MEMO

re: Response to Comments issued by Norfolk County, April 16 2025

Proposed Mini Storage, 310 Fourteenth Street West, Simcoe

Site Plan / Landscape Plan

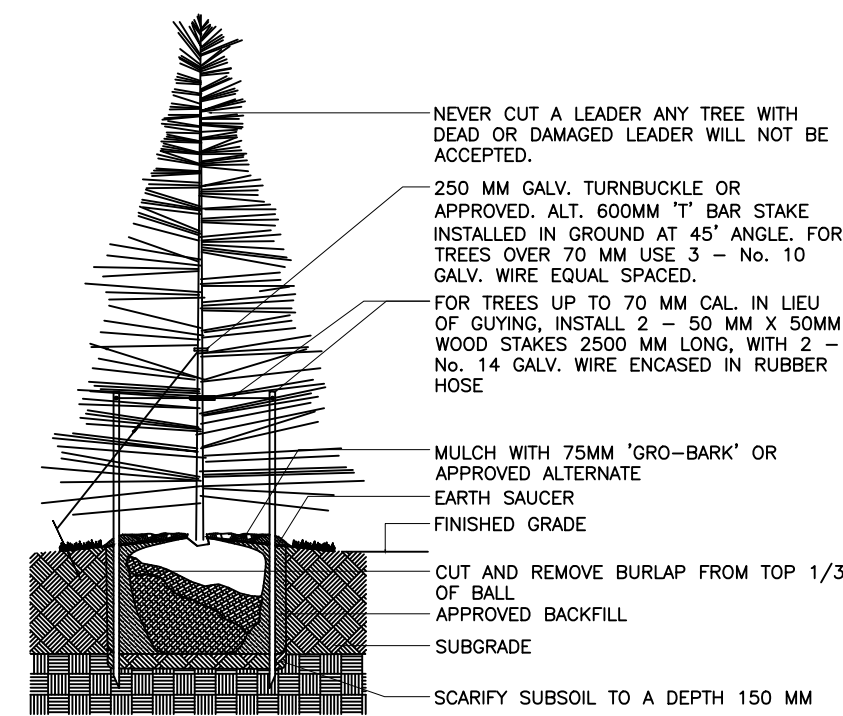
- there are no proposed freestanding light poles / fixtures
 - exterior lighting will be limited to wall pack lighting, now illustrated on drawing SP1.

- all lighting to be dark sky compliant, (note has been added to SP1).
 - the two existing hydro poles along the frontage have been identified.
 - reference site lighting note on drawing SP1

THERE IS NO PROPOSED FREESTANDING EXTERIOR LIGHTING. (WALL PACKS ONLY - REFERENCE LOCATIONS ON THIS DRAWING).
REFER TO BUILDING PERMIT ELECTRICAL DRAWINGS FOR ALL LIGHTING, LIGHT FIXTURE TYPES, WIRING, UTILITY POLES ETC., LOCATIONS AND SPECIFICATIONS.

Grading and Drainage Plan

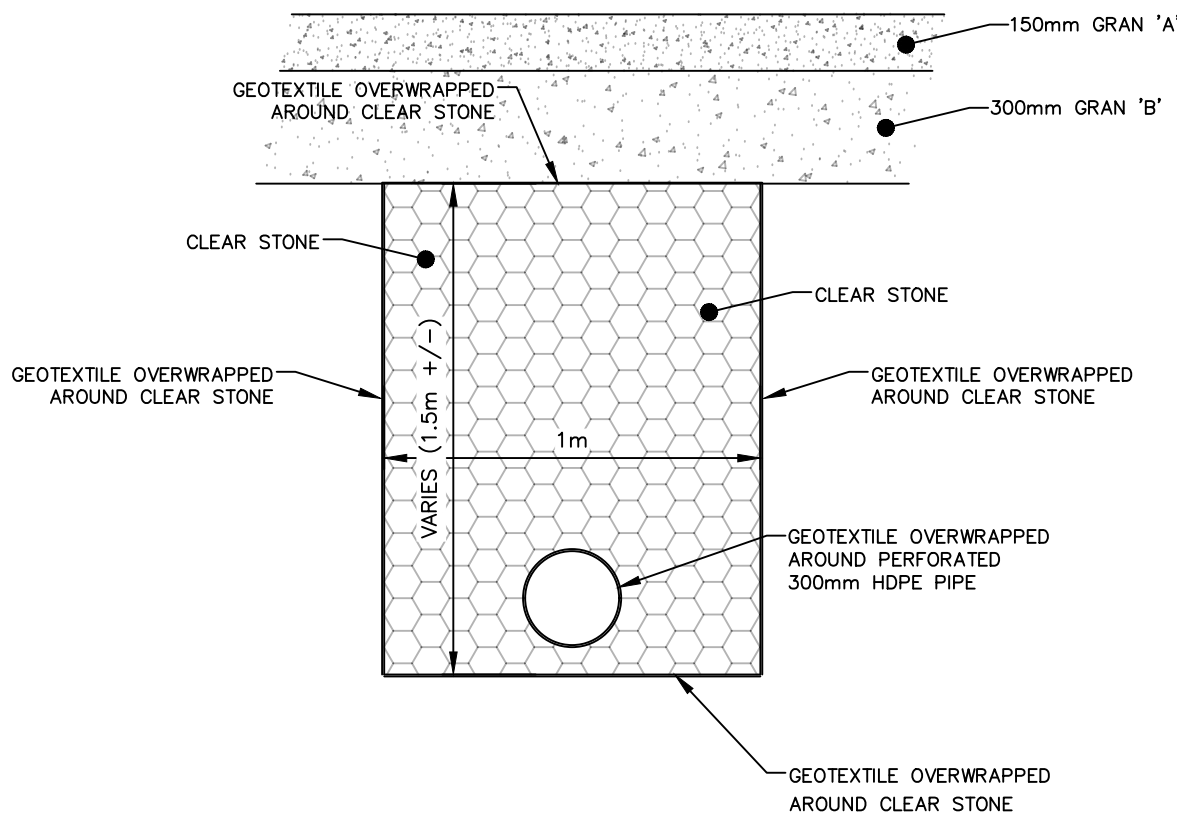
19. The CSP is a new installation. It is now specified at 450mm.

20. Headwalls to be removed. This has now been noted on drawing.

21. The proposed grading has been revised to remove the emergency overflow at the front of the property, the emergency overflow is now directed solely to the fire pond. Nevertheless, Curbing has been added at front to stabilize edge of gravel.

*EXISTING DRIVEWAY CULVERT
TO BE REMOVED AND REPLACED
WITH NEW 450mm CSP.
EXISTING CONCRETE HEADWALLS
ARE TO BE REMOVED.

Site Servicing Plan

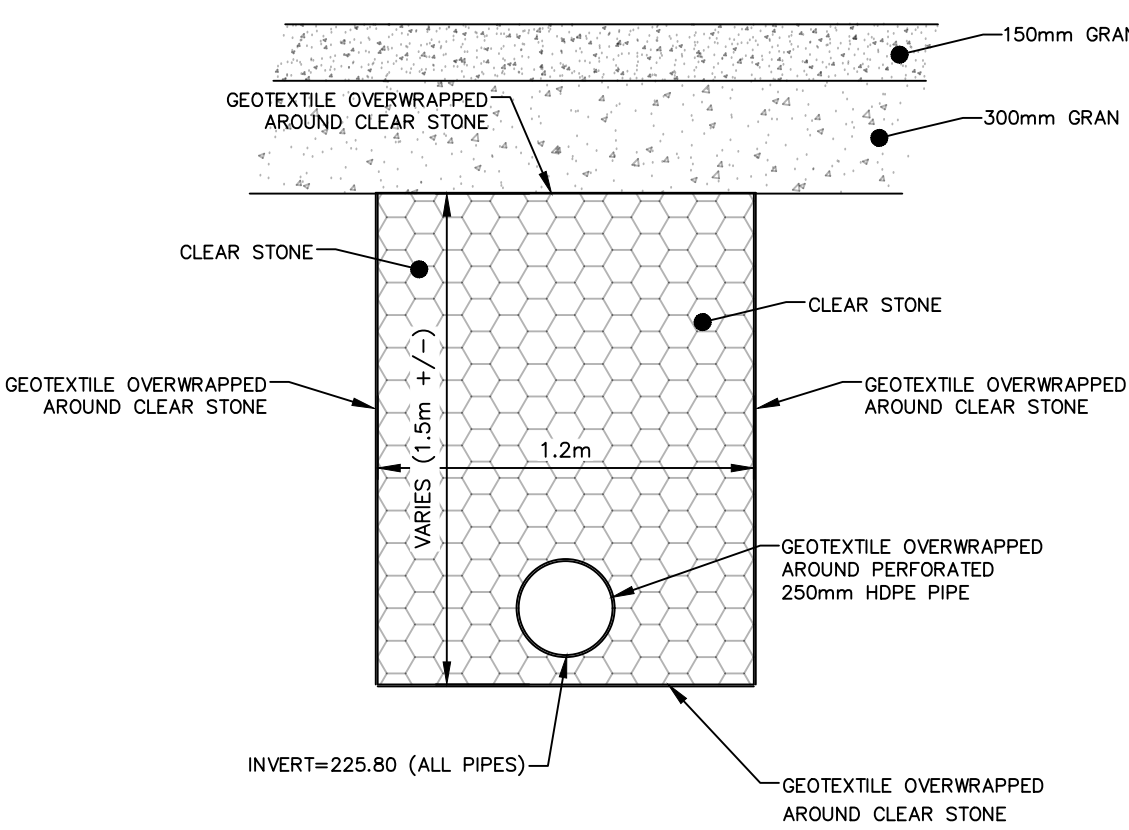
- 6b. drawing revised to indicate cistern (no proposed private well).
- 6c. drawing revised to indicate cistern (no proposed private well).
- 6d. drawing revised to indicate cistern (no proposed private well).
- 7. A source protection report has been added as an Appendix to the FSR (Appendix 1)

- CISTERN IS PROPOSED TO PROVIDE DOMESTIC WATER SERVICING (NO PRIVATE WELL IS PROPOSED).

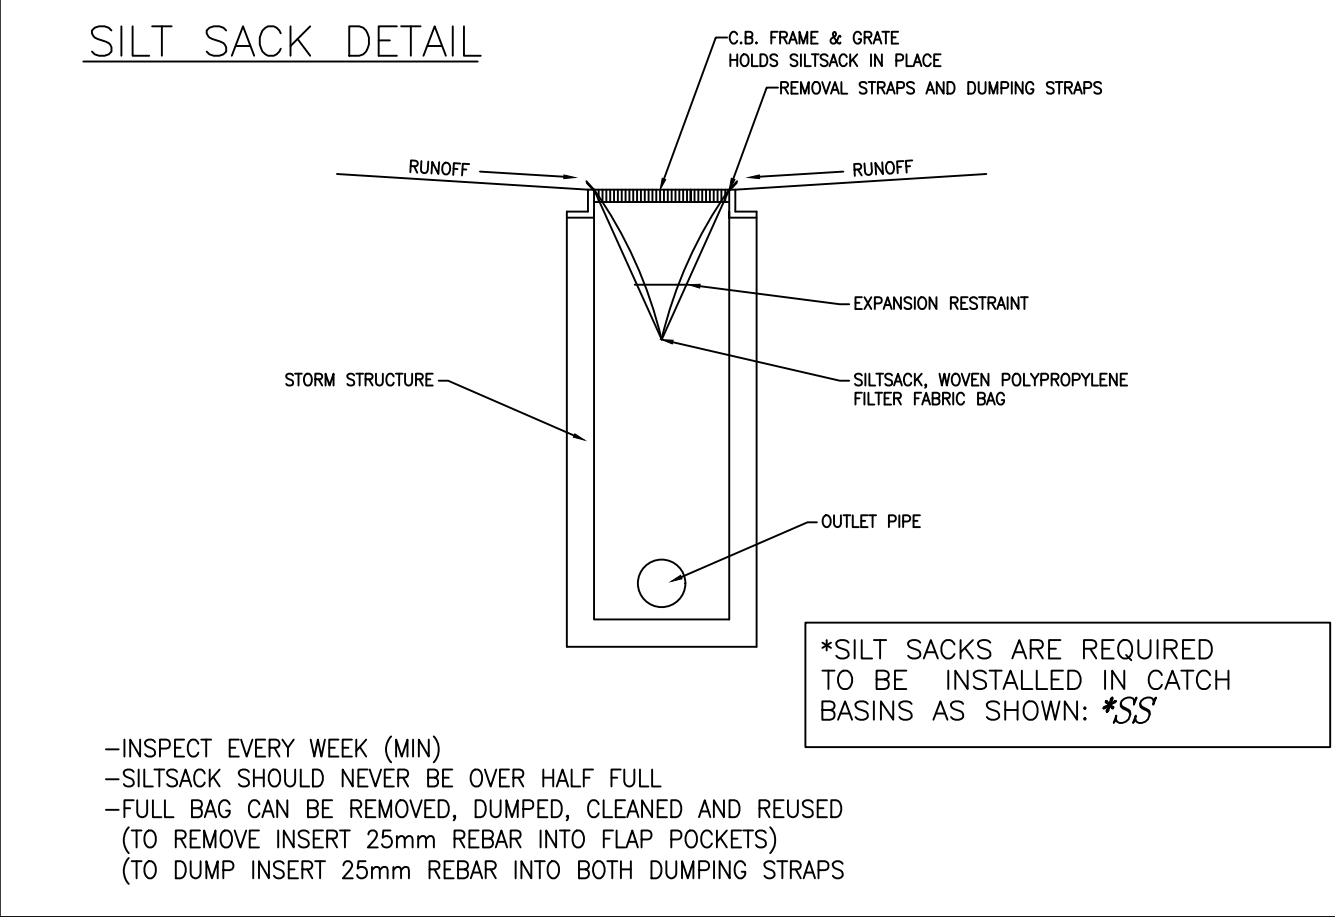
34. Reference to silt sack detail has been corrected.

9. CATCH BASINS TO HAVE SILT TRAPS INSTALLED FOR THE DURATION OF CONSTRUCTION. REFERENCE SILT SACK DETAIL ON
